SUBJECT: Contract 8078, I-5 Columbia River Bridge Temporary Pile Test Program
CO #001 – Added Boring Locations

CONTRACT NO: 008078 FEDERAL AID NO:
CONTRACT TITLE: I-5, COLUMBIA RIVER BRIDGE TEMPORARY PILE TEST PRO
CHANGE ORDER NO: 1 ADDED BORING LOCATIONS

FILE NAME	\$\$\$\$\$DESIGNFILENAME\$\$\$\$\$	REGION NO.	10	STATE	WASH	FED.AID PROJ.NO.						I-5 COLUMBIA RIVER BRIDGE TEMPORARY PILE TEST PROGRAM	PLAN REF. NO. PLS1
TIME	\$TIME\$	JOB NUMBER	10X314	CONTRACT NO.	C8078	LOCATION NO.	XL3604						
DATE	\$\$\$\$DATE\$\$\$									Columbia River CROSSING	PILE LOCATION AND SCHEDULE		
PLOTTED BY	\$\$USERNAME\$\$												
DESIGNED BY	M. DEML												
ENTERED BY	J. BURKE												
CHECKED BY	C. WERTS												
PROJ. ENGR.	F. GREEN	C.O. #1 - ADDED BORING LOCATIONS	1/13/11	MD									
REGIONAL ADM.	D. WAGNER	REVISION	DATE	BY

Contract 8078
 Change Order No. 1
 Sheet 3 of 3

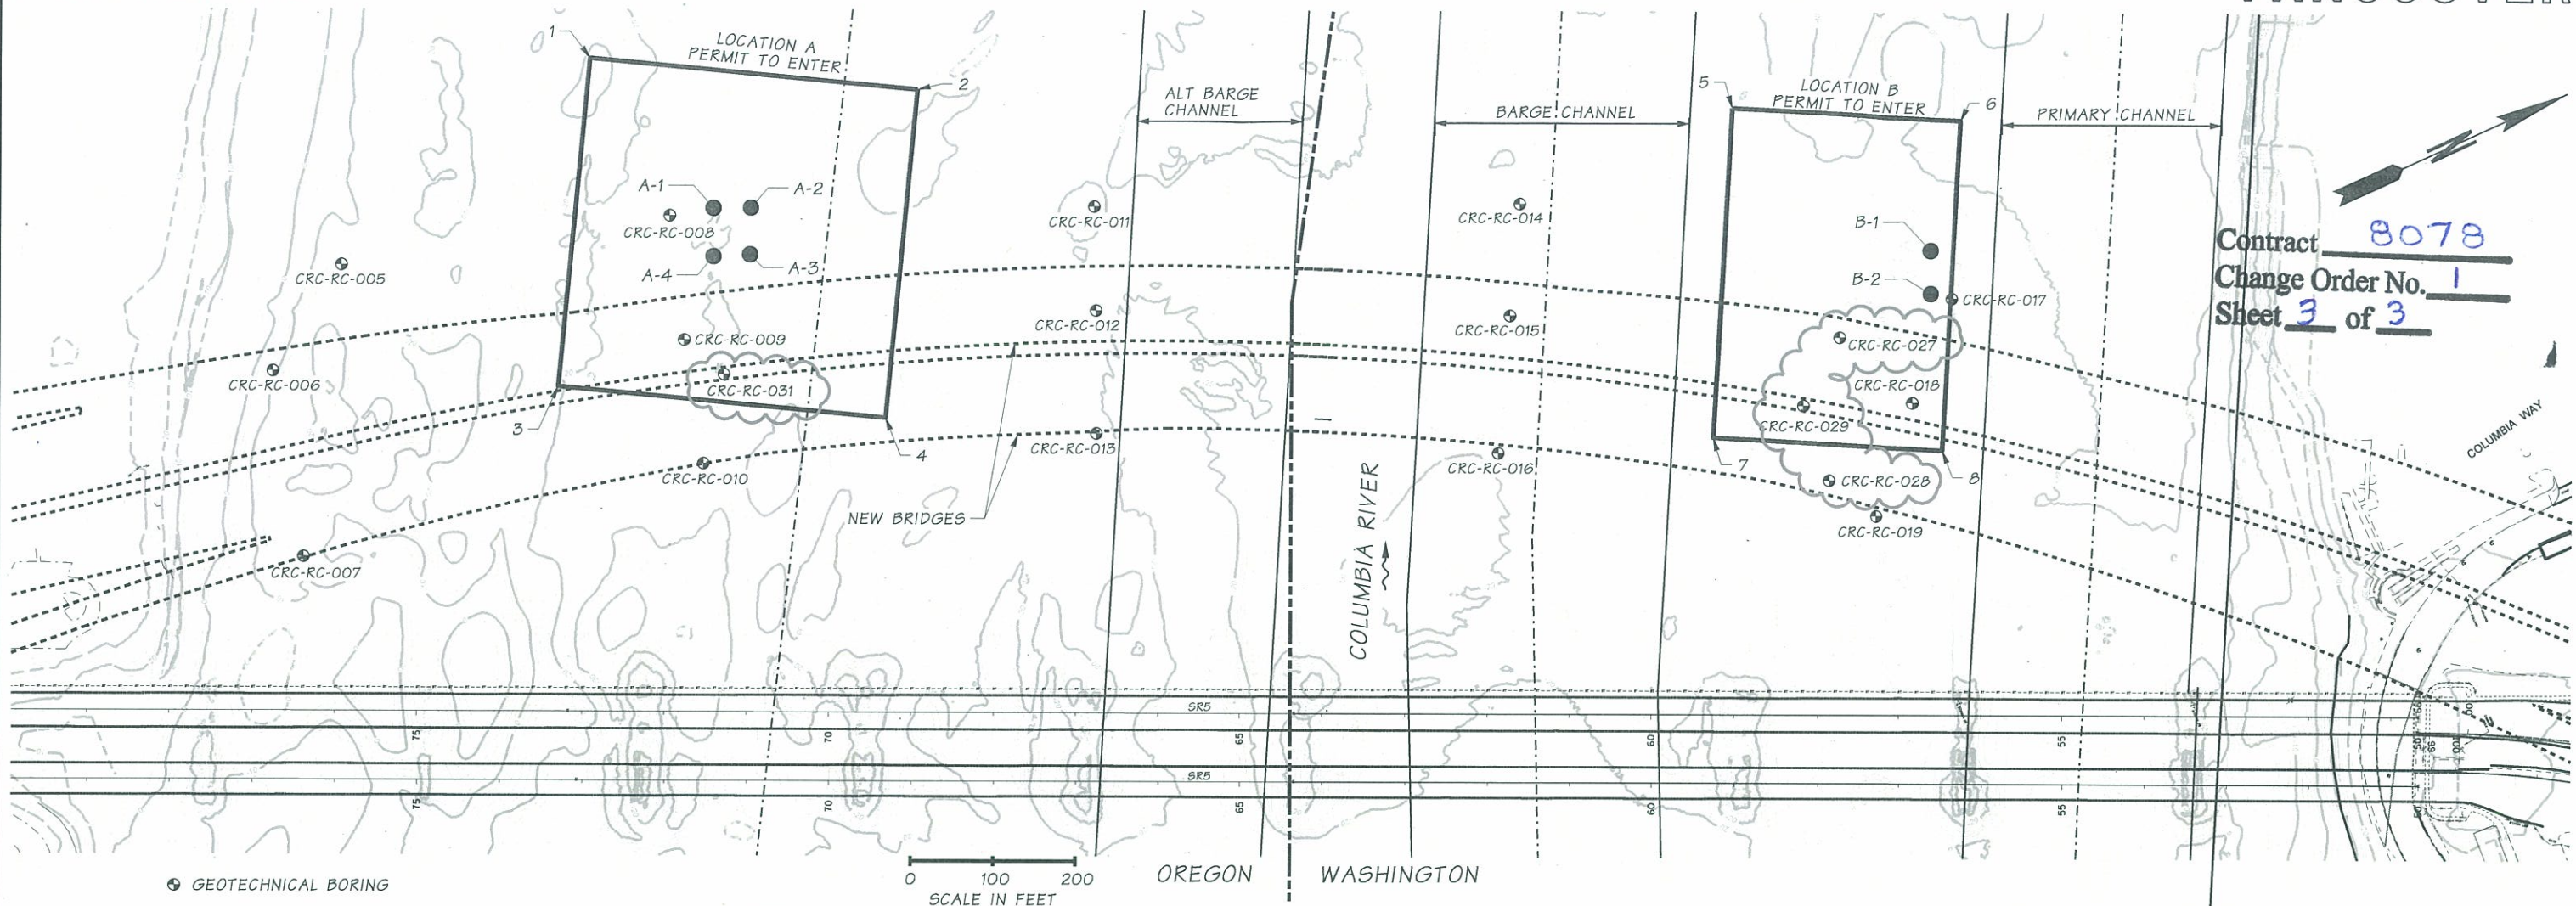
This change order revises contract plan sheet PLS1 by adding additional geotechnical boring locations. Replace contract plan sheet PLS1 with page 3 of this change order.
